## REMARKS

This AMENDMENT UNDER 37 CFR 1.111 is filed in reply to the outstanding Office Action of October 4, 2002, and is believed to prima facie place this case in condition for allowance for the following reasons.

**“VERSION WITH MARKINGS SHOWING CHANGES MADE”**

FIG. 1A (PRIOR ART)

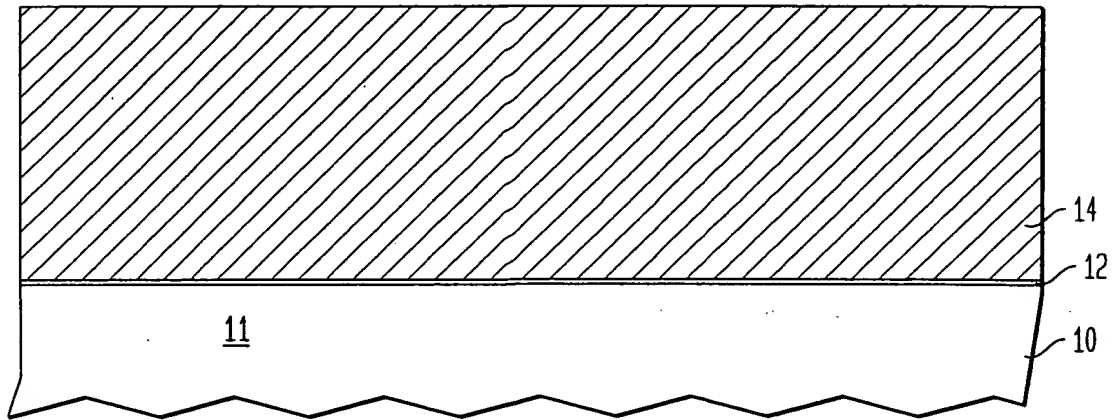
OK Responsive to paragraph 3 of the Official Action, proposed corrections to Figures 1A, 1B, 1C, 1D, 1E and 1F are attached hereto.

approved  
Lake

FIG. 1E (PRIOR ART)

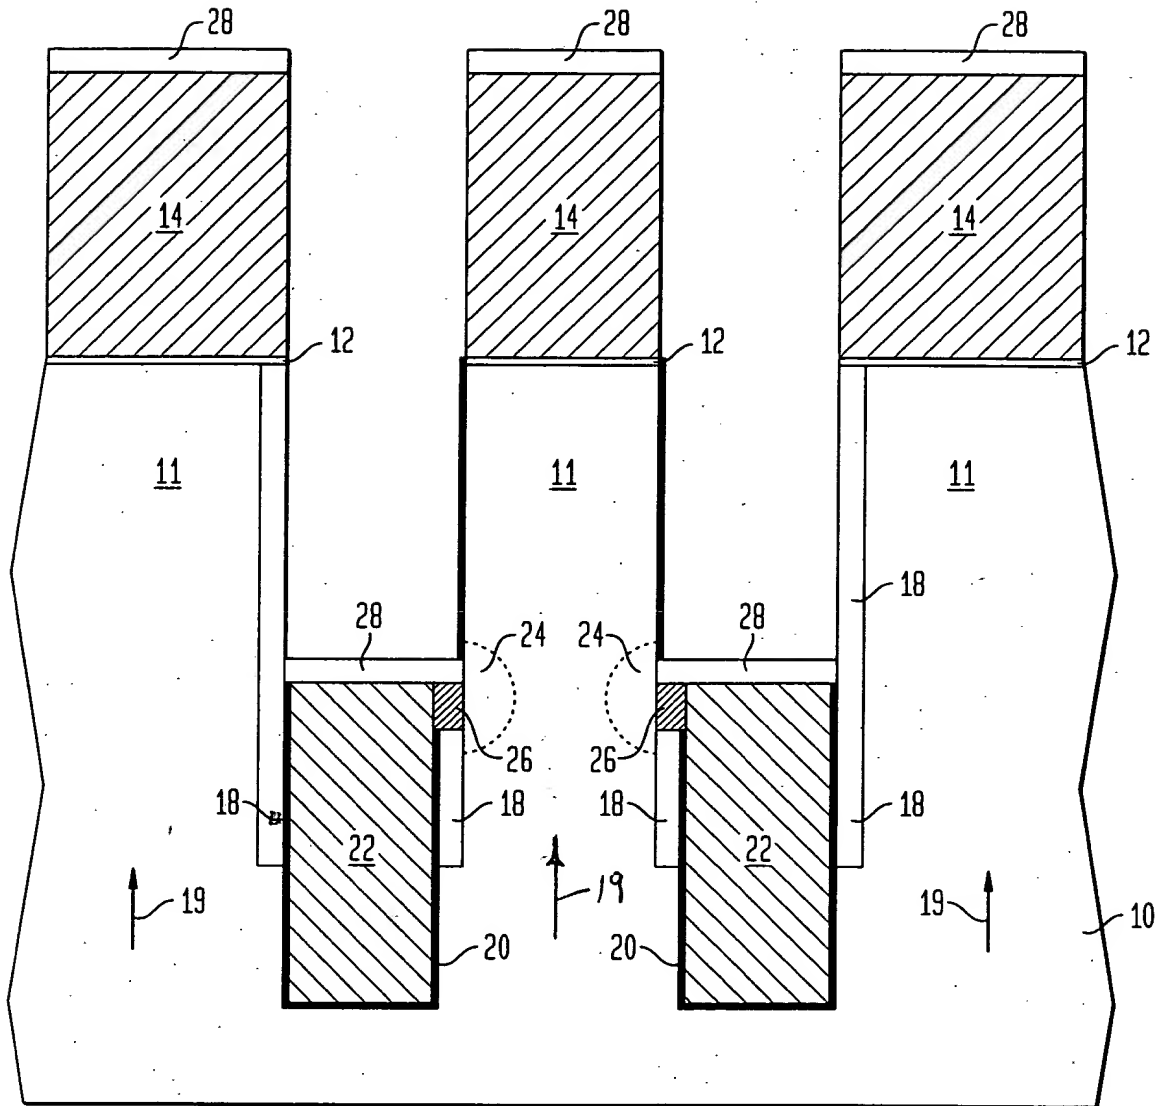
OK Responsive to paragraph 5, the paragraph extending between pages 3 and 4 has been amended to clarify the subject matter in question which is clearly illustrated in Figure 1E.

approved  
Loke
